- 8. Bear Cove Airpark Addition; KPB File 2024-014**
McLane Consulting Group / Kersten
Location: Pomeroy Road
Remote Area

**ITEM #8 - PRELIMINARY PLAT
BEAR COVE AIRPARK ADDITION**

KPB File No.	2024-014
Plat Committee Meeting:	February 26, 2024
Applicant / Owner:	Jack C Farnworth Residuary Trust of Soldotna
Surveyor:	James Hall / McLane Consulting Inc
General Location:	Bear Cove Kachemak Bay

STAFF REPORT

BEAR COVE AIRPARK ADDITION

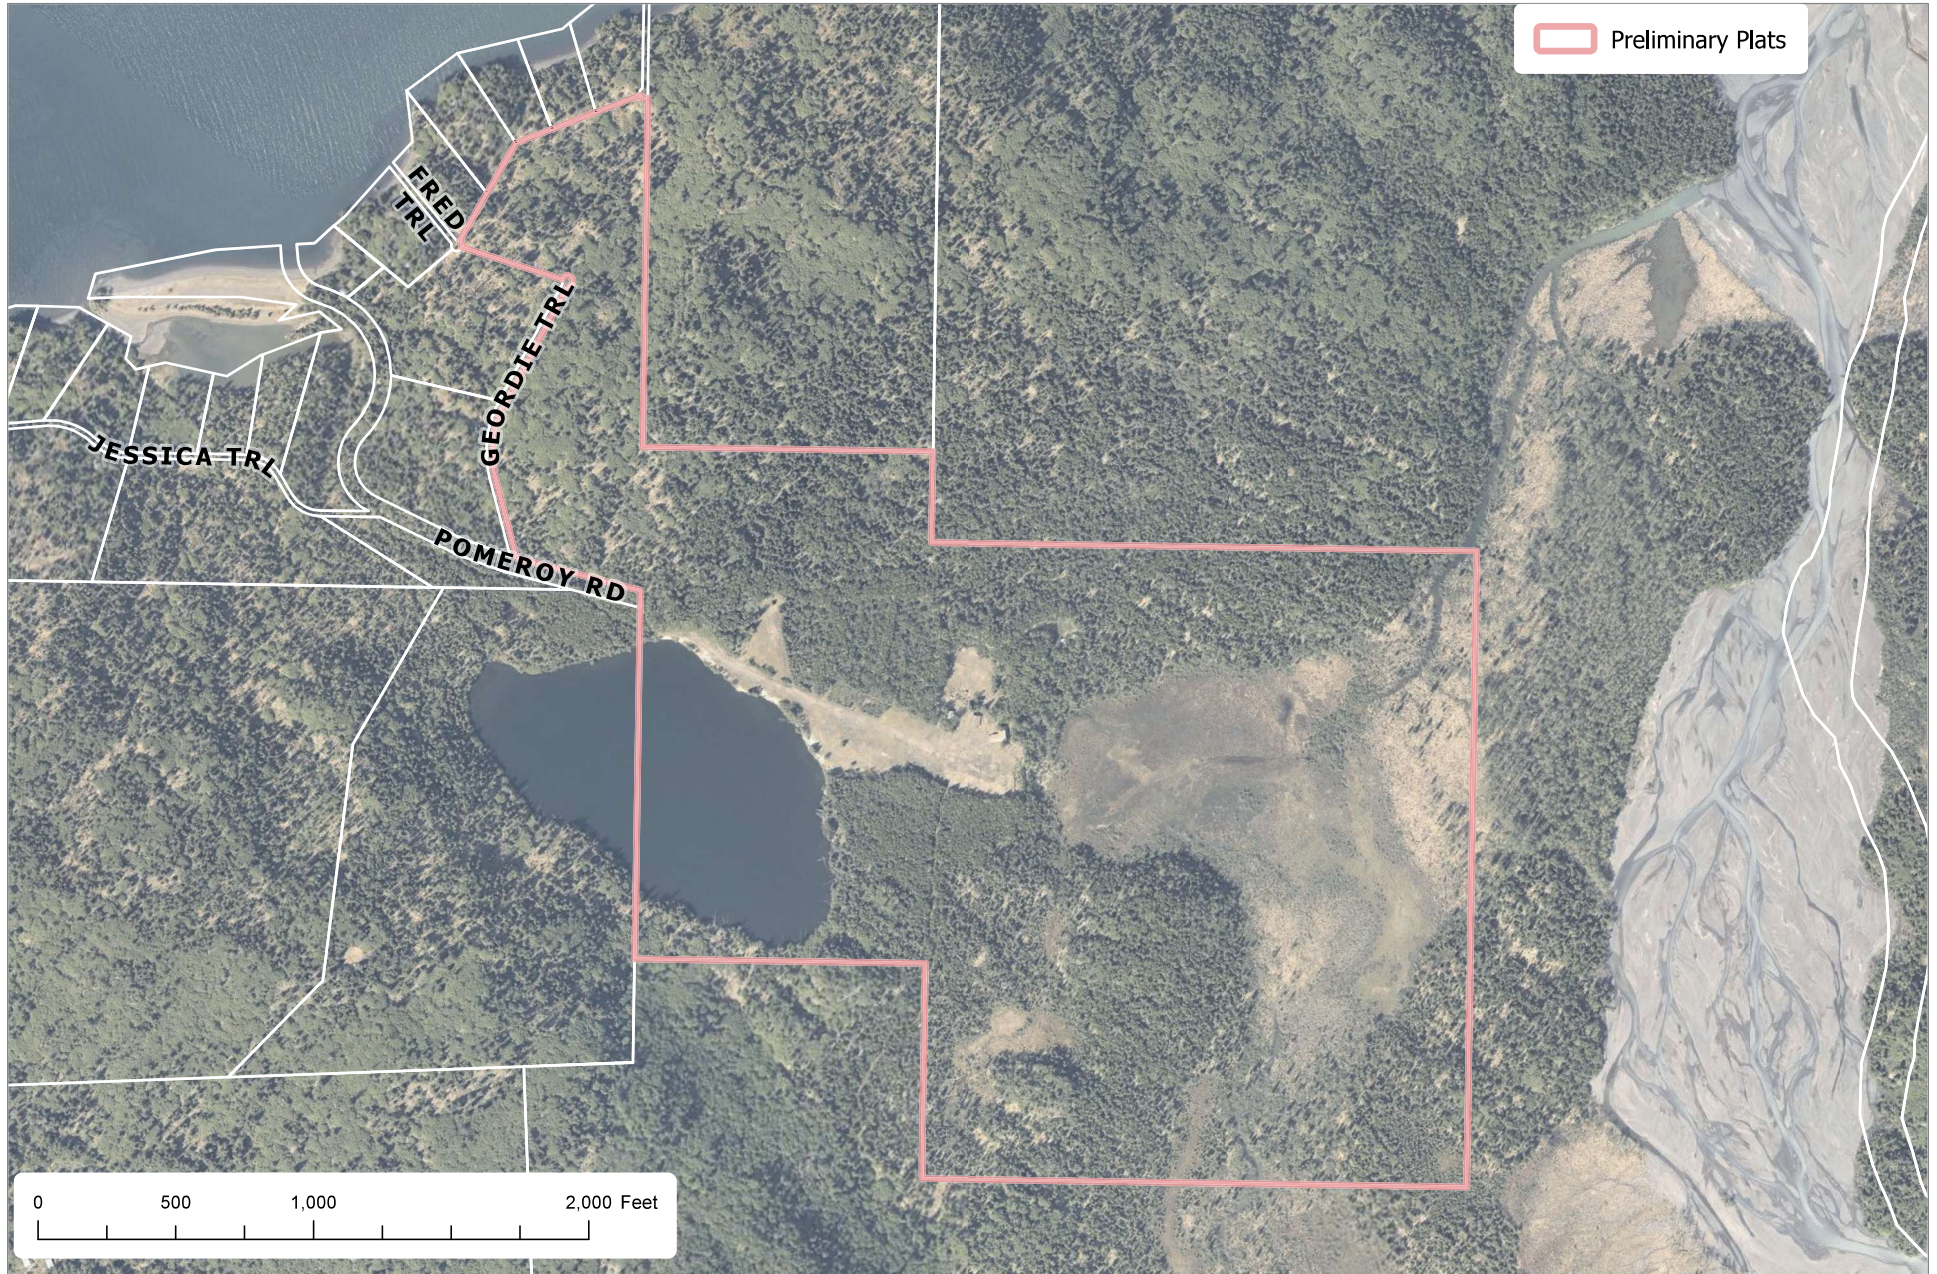
The road appears to have some steep segments along the route. **Staff recommends:** the surveyor submit centerline profiles and cross sections for RSA review as additional right-of-way or easements may be required for side slopes.

The plat contains many steep areas as shown by the contours and shading on the drawing. The contours should be removed for the final submittal and the shading lightened.

The land was first surveyed as US Survey 3018 and 3355 by the US Department of Interior in July of 1954. In 1955 US Survey 3355 has a supplemental plat drawing and filed with it dividing Lot 1 Dickson Subdivision HM 83-25 subdivision US Survey 3018 into 24 lots and a 60' road dedication leading to this subject property. Since the platting Dickenson Dr has been renamed to Pomeroy Rd and should be changed on the drawing.

HEA has requested the front 10 feet of the 20 building setback be labeled as a utility easement with a plat note.

- KPB file no is 2024-014
- Dickenson Dr has been renamed to Pomeroy Rd, please correct.
- Identify the few roads that are in the area on the vicinity map.
- Parcels to the east and south should be labeled "unsubdivided"
- Create a typical detail for the 10' utility easement and 20' building setback to be shown instead of on drawing.

Label the line of the lake in the plat and on adjacent property or add the line type to the legend

- The front 10 feet of the building setback and the entire setback within 5 feet of the side lot lines, is a utility easement granted with this platting action.
- Roads must meet the design and construction standards established by the borough in order to be considered for certification and inclusion in the road maintenance program (KPB 14.06).
- The borough will not enforce private covenants, easements, or deed restrictions per KPB 20.60.170.
